MEMORANDUM

Our Ref: EP/DC/PP/2017/0312

Location: O. S Grid Ref: 345 495 Land at Rubery Way, Caia Park, Wrexham.

Development: Application for variation of condition no. 10 imposed under planning permission P/2015/0587 to allow amendment to site layout.

7.5t Panel Van
Overall Length
Overall Width
Overall Body Height
Min Body Ground Clearance
Track to Lock
Lock to Kerb
Kerb to Turning Radius

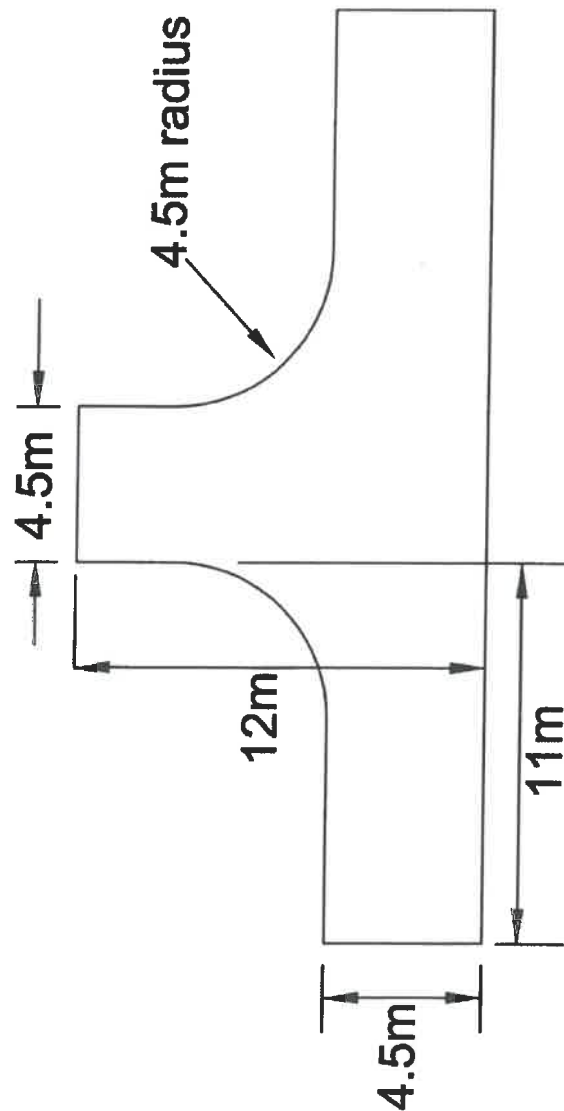
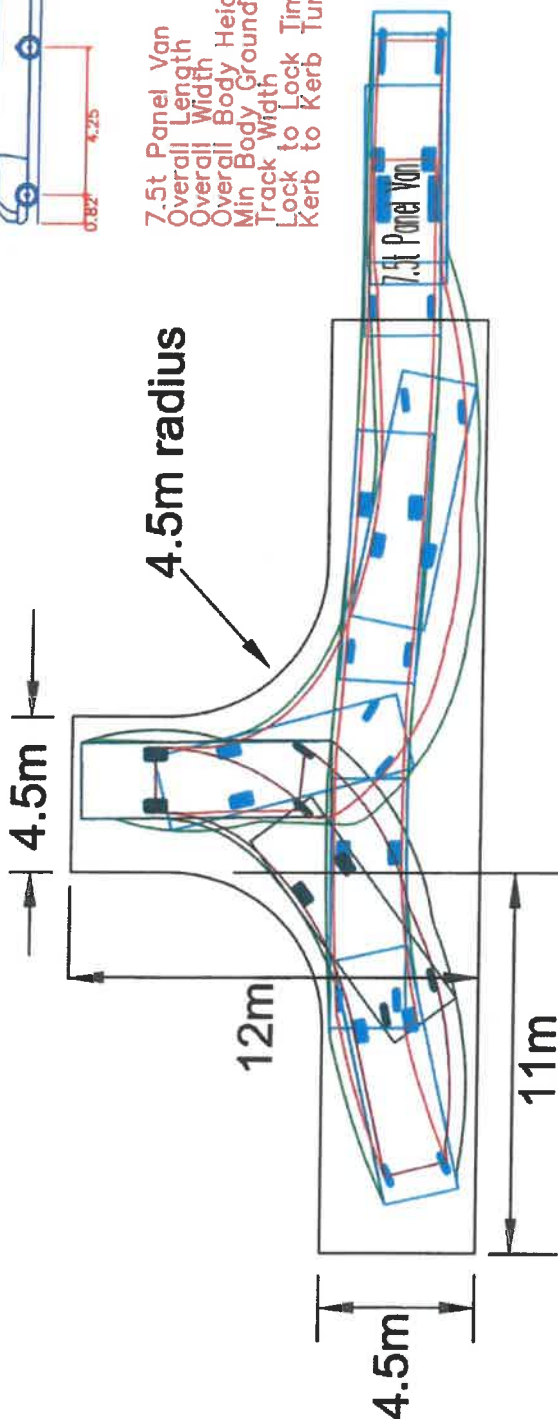
I would recommend any proposed development includes the provision of a suitable turning head constructed to adoptable standards to serve both the existing and proposed dwellings (see note). Details of the required turning head dimensions attached.

The full extent of the proposed turning head has not been indicated on the submitted layout plan. The proposed turning head will need to be 11m deep heading towards / up to the existing emergency access serving Whitegate Industrial Estate (see attached detail). Any proposed turning head will need to be provided with appropriate surface water drainage.

Please ask the applicant to provide a revised layout plan indicating the full extent of the proposed turning head and location of existing / proposed gullies.
